Southern Services Ltd (Extension 2)

DOCTOR BARI, ZIRABO, ASHULIA, SAVAR, DHAKA

11 November 2024

Compression strut layout plan

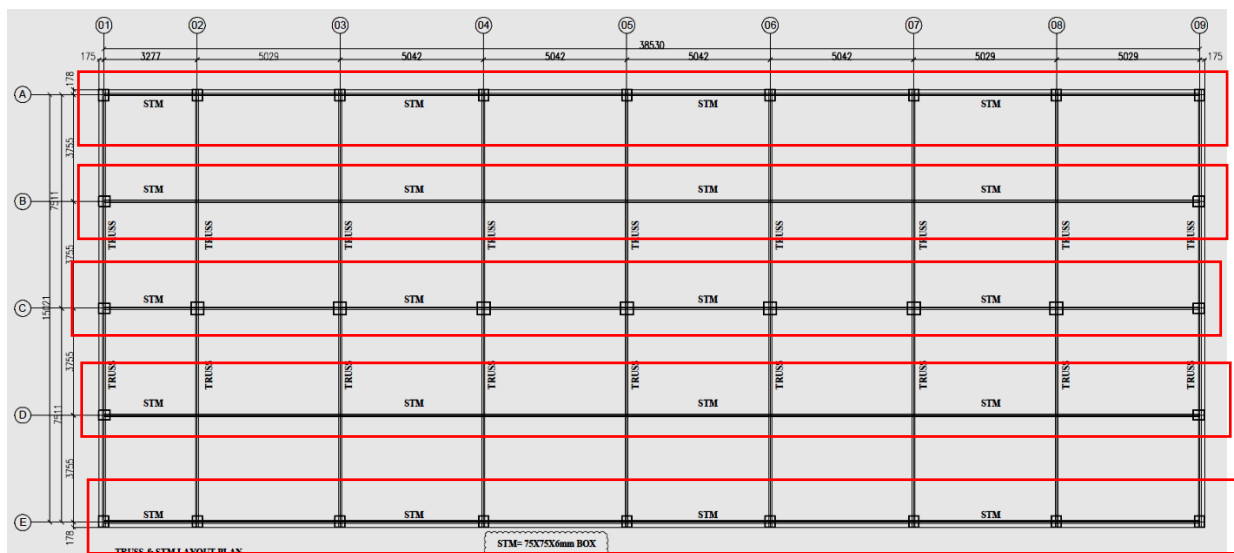
Observation-1: Lack of lateral stability system (bracing & strut along the ridge). (Building 2)

Description: Lateral load transfer media compression struts were missing along the ridge. So, the lateral stability of the structure is questionable. A design report was available for the building. The design report did not incorporate the adequacy of steel members' connections. However, the building engineer is required to incorporate an adequacy check of steel member's connections in the design report including the review against lateral loading, and submit it to RSC for detailed review. Once the review of design documents is finalized, implement the proposed remedial works (if any).

Item No.	Observation	Action Plan	Timeline
01	Lack of lateral stability system (bracing & strut along the ridge) (Building 2)	The design report needs to be reviewed against lateral loading, incorporate the connection adequacy check in the design report, and submit it to the RSC for detailed review.	within 6 weeks
02		Carry out the suggested remedial works.	within 6 months
03	Nonstructural elements found not anchored/braced (Building 2)	Factory is required to brace/anchor all non-structural elements.	within 6 months
